**Reference:** Case No. PD-270-RBN, The Avenue at Denton Tap, a zoning change request from Commercial to a Planned Development to allow 29 multifamily units and 8,575 square feet of office/retail uses on 1.77 acres of property located at the northwest corner of Southwestern Boulevard and South Denton Tap Road.

**STAFF REPORT**

**CASE NO. PD-270-RBN, The Avenue at Denton Tap**

Site Plan

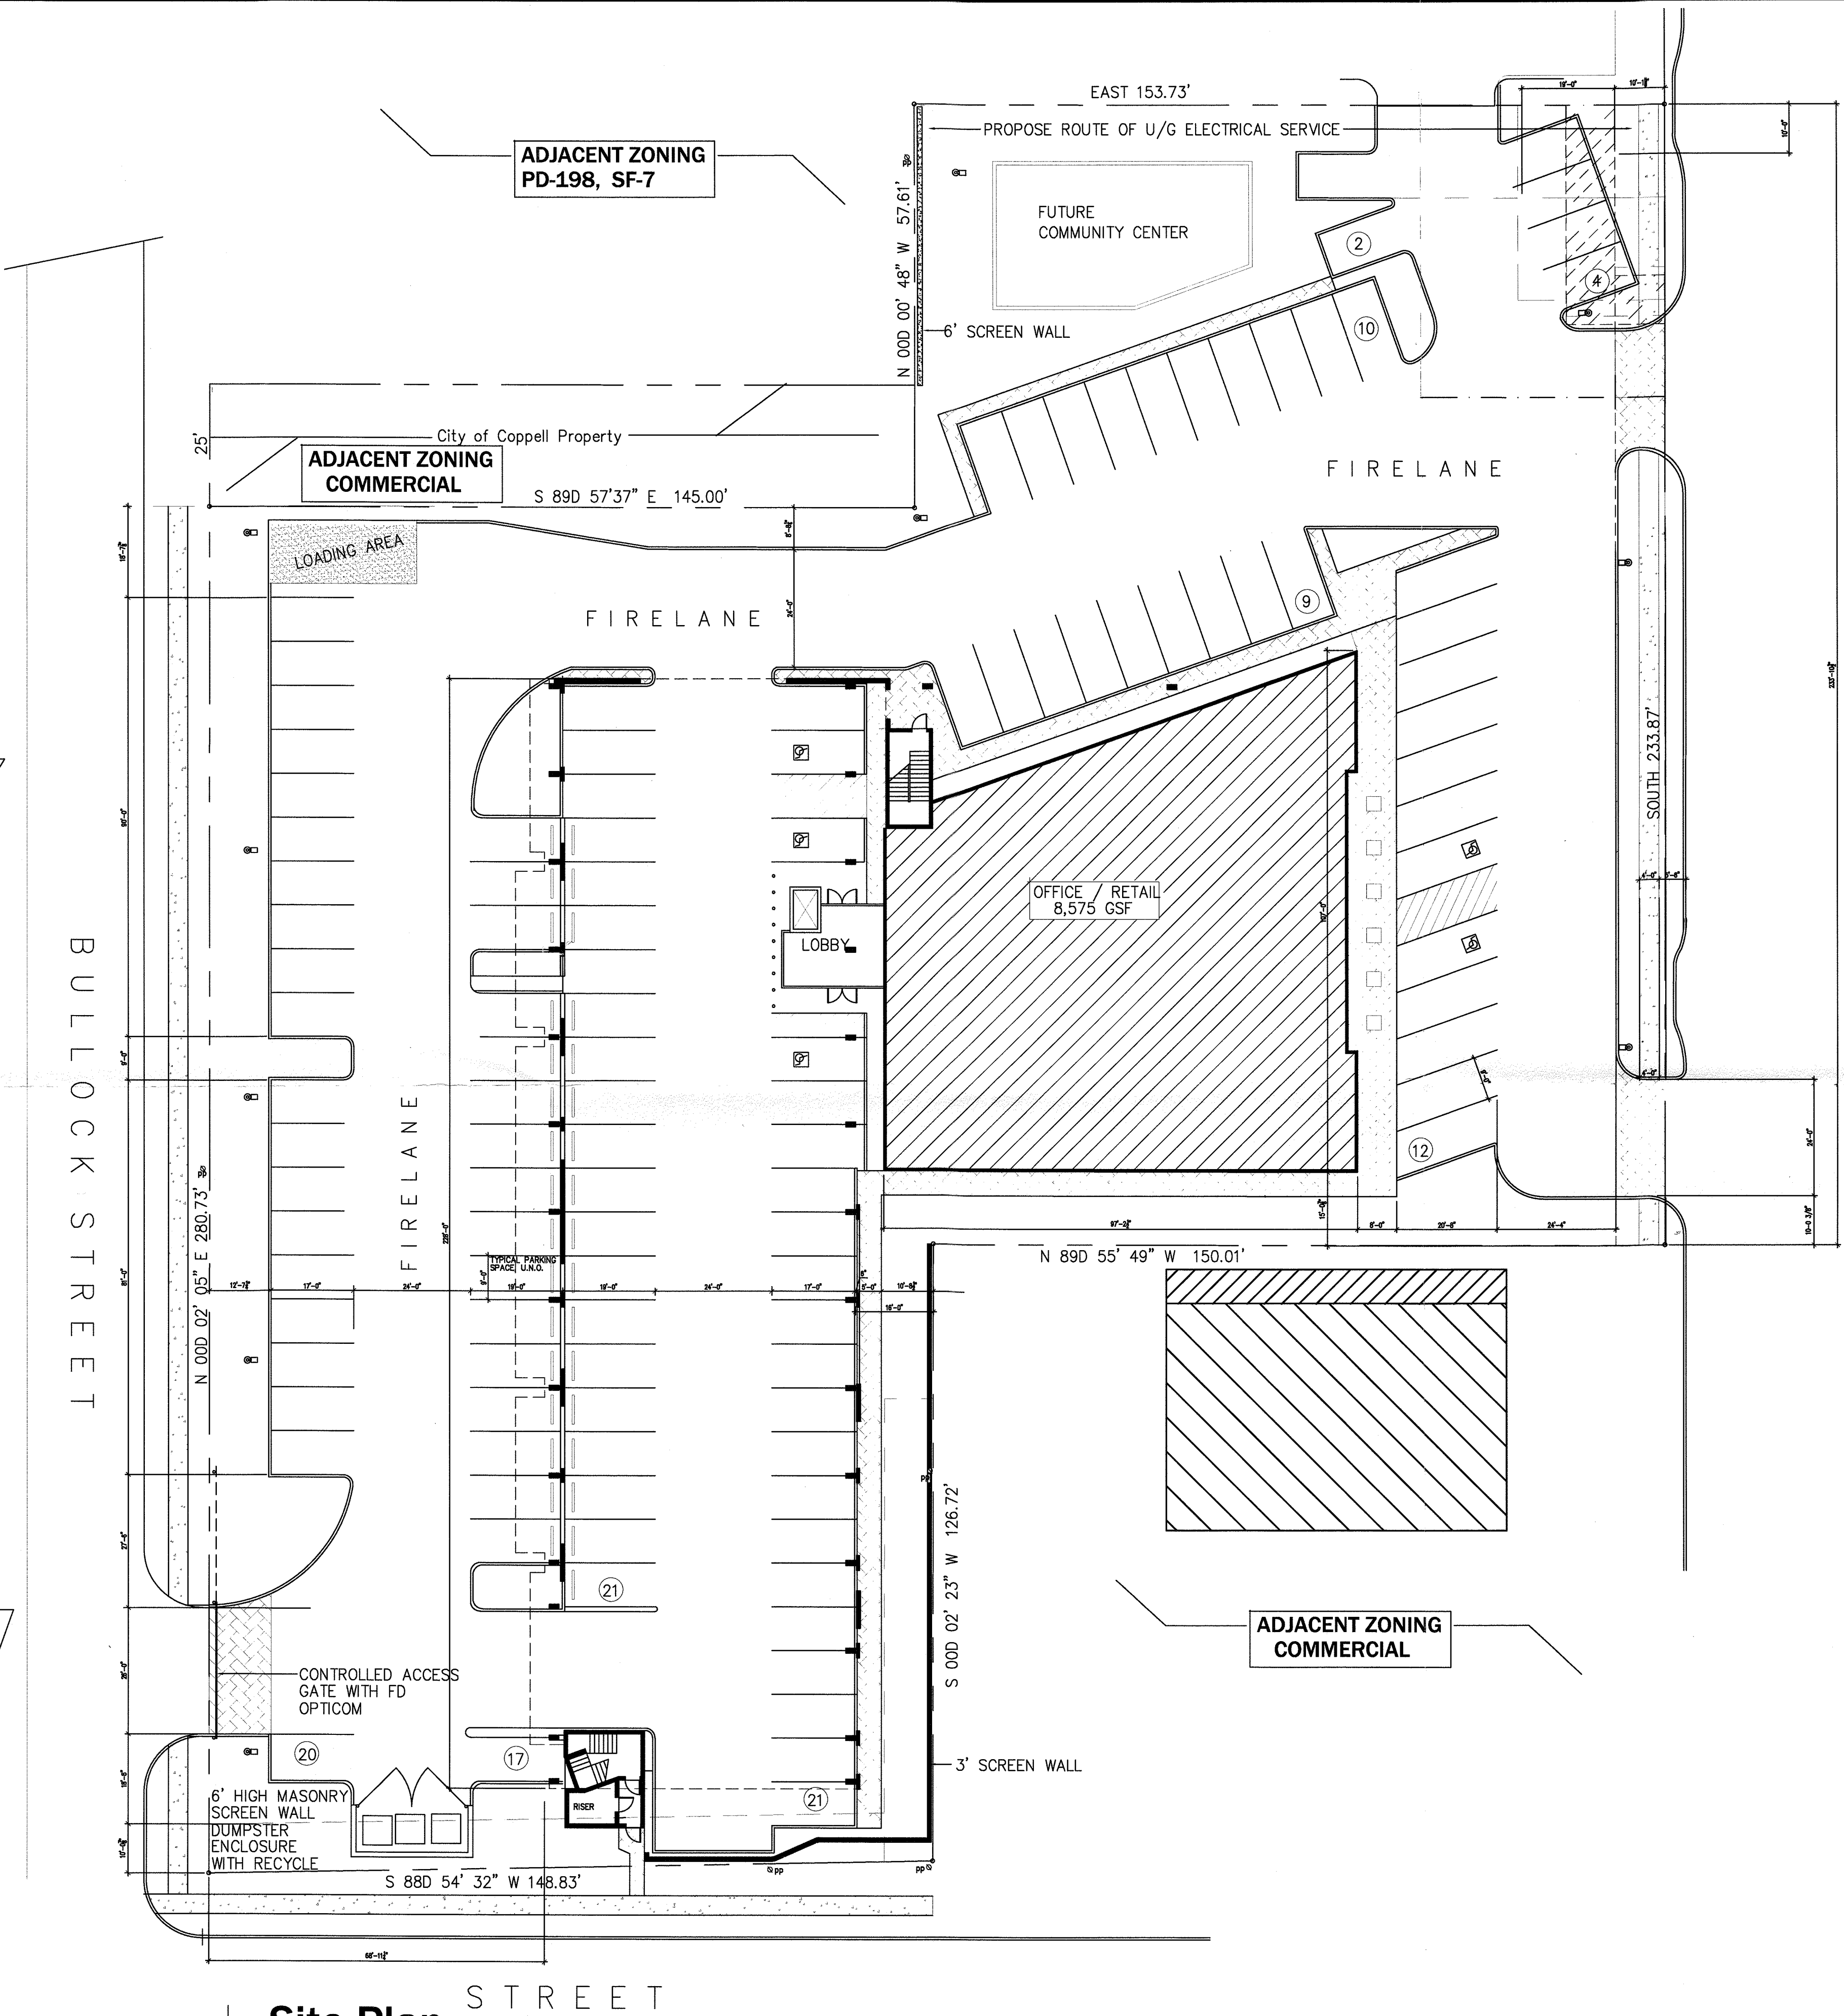
This building is proposed to be setback 63 feet from Denton Tap Road and 69 feet from Bullock Street. It is recommended that the 69-foot setback be supported to keep a buffer and transition from the residential neighborhood into the proposed higher intensity mixed use development.

A 36-foot setback is proposed along the northwest property line, which is adjacent to a 25-foot right-of-way providing a greater separation from the residential neighborhood. The main building is 63 feet from the Denton Tap Road right-of-way where the RBN District calls for a building to be no more than 15 feet from the lot line. Staff can support this deviation, as both a drive and parking are warranted for the office/retail use.

This proposal exceeds the 116 parking space requirement by providing 119 spaces. Both the *Comprehensive Plan* and the RBN District encourages structured (garage) parking. In this development 41 of the 119 spaces are contained within the structure. It is recommended that this parking area on the first floor be better screened with a three-foot masonry wall incorporated into each façade and this has

been listed as a condition of approval. Beyond the structured parking are 41 spaces in a parking lot. This area is proposed to be screened with a 12 foot wide landscaped area east of Bullock Street. The proposed off-street parking and drive (similar to a slip street recognized in the Comprehensive Plan). The proposed parking located on the Denton Tap Road side is angled with a one-way drive to provide an opportunity for streetscaping without actually having dangerous on-street parking on Denton Tap.

1 LANDSCAPE PLAN  
SCALE 1"=20'

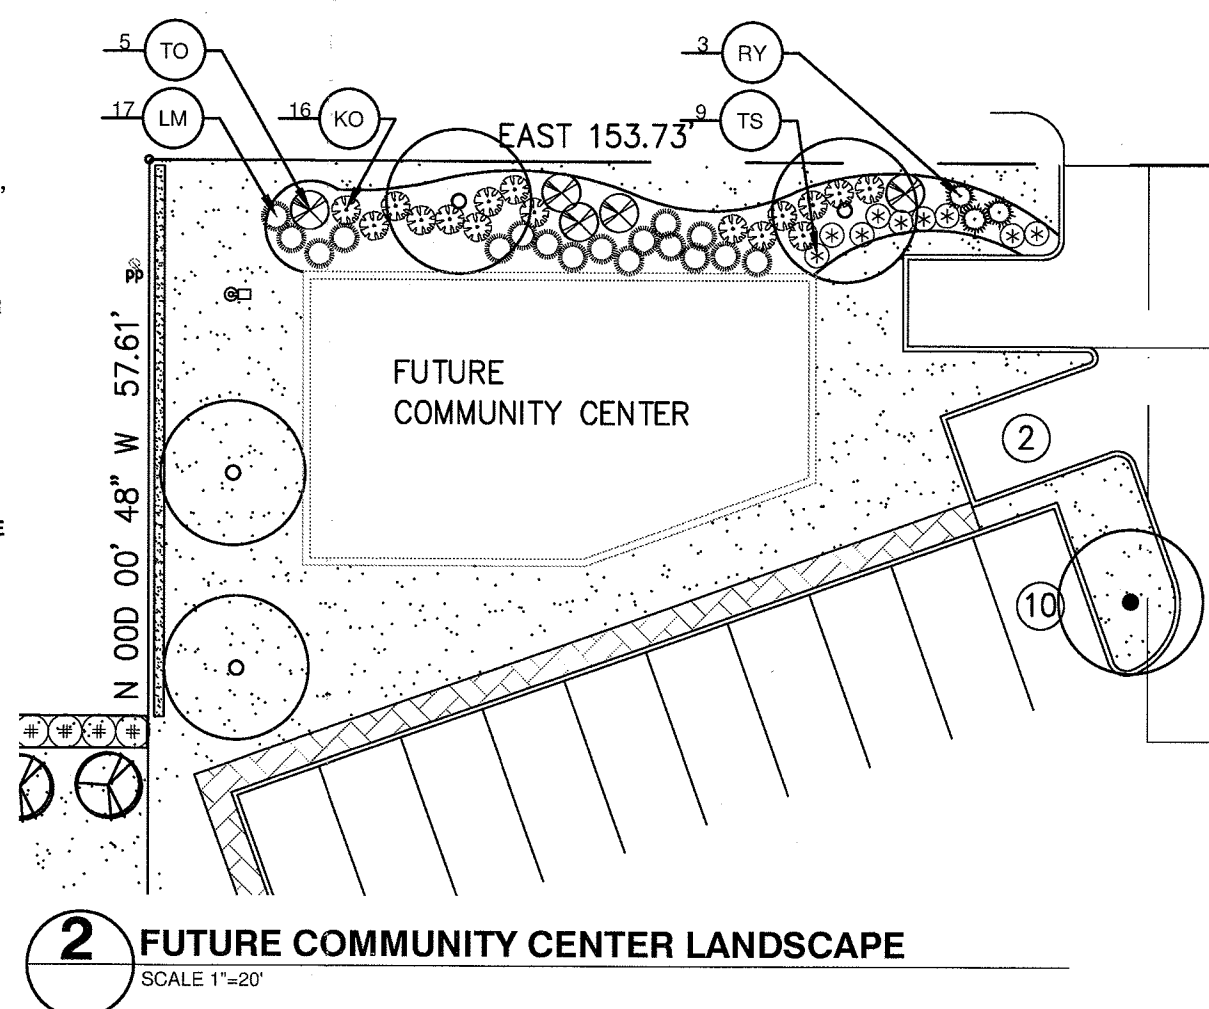
The landscape areas within a RBN District are different than the typical business zoning districts where under the RBN, a minimum 15% open space/common area is required. The proposal indicates that 17% has been provided. The streetscaping of the retail/office area is adequate where street trees are being provided. However, additional landscape islands are being recommended in the parking lot where there is no structure over the parking. Not more than 15 parking spaces are typically permitted without an island and one island is required at the end of each parking row; therefore, three islands are recommended. Also, the applicant has agreed to add an evergreen area of landscaping (containing Nellie R. Stevens and Eastern Red Cedars) to the 25 foot right-of-way strip located northwest of the property to better buffer/screen this proposal from the existing residential neighborhood.

8. Include three 150-square-foot landscape islands with an overstory tree within the proposed surface parking area where not under the structure. No more than 15 spaces are typically permitted without an island and one island is required at the end of each parking row.

11. Submit Future Community Center plans to the Director of Planning for administrative review, prior to permitting or construction.
12. Label the 25-foot right-of-way northwest of the site as City of Coppell Property. Include Eastern Red Cedars and Nellie R. Stevens south of the existing fence.

13. Overhead electric line shall be relocated and buried.
14. List all requested variances to the RBN District in the PD Conditions table.
15. Revise the Landscape Plan to include interim and future landscaping for the "Future Community Center" portion of the site.

**01 Elevation at Sliding Gate**  
Scale: 1/4" = 1'-0"

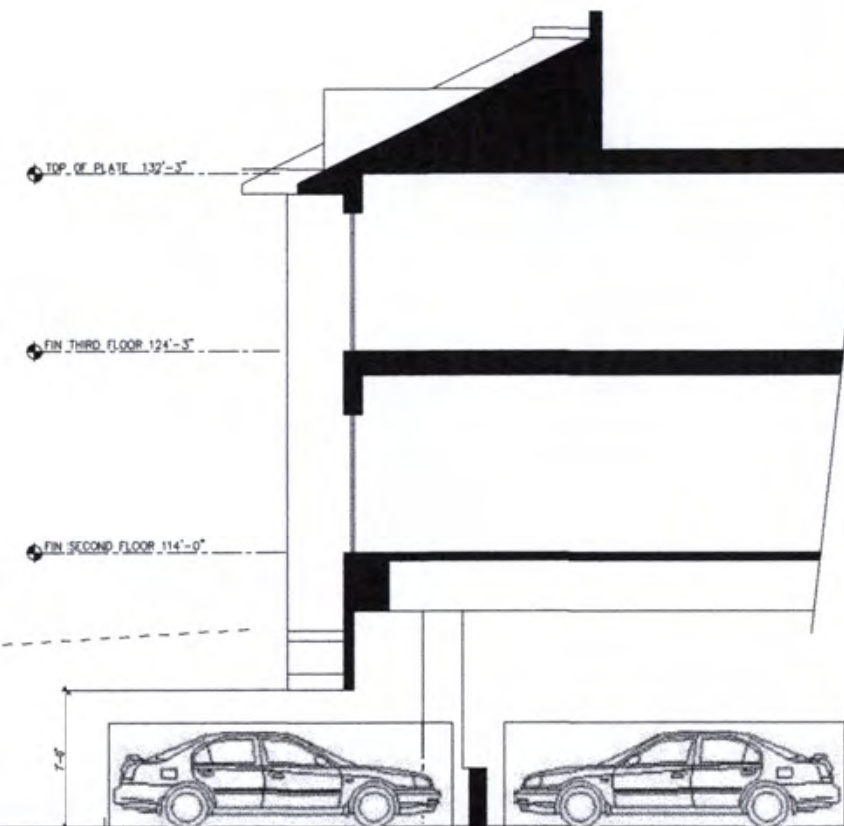
16. Include a gate with controlled access (include opticom for Fire Department) at the southwest access point off of Bullock.
17. Relocate the dumpster enclosure to the south end of the project.
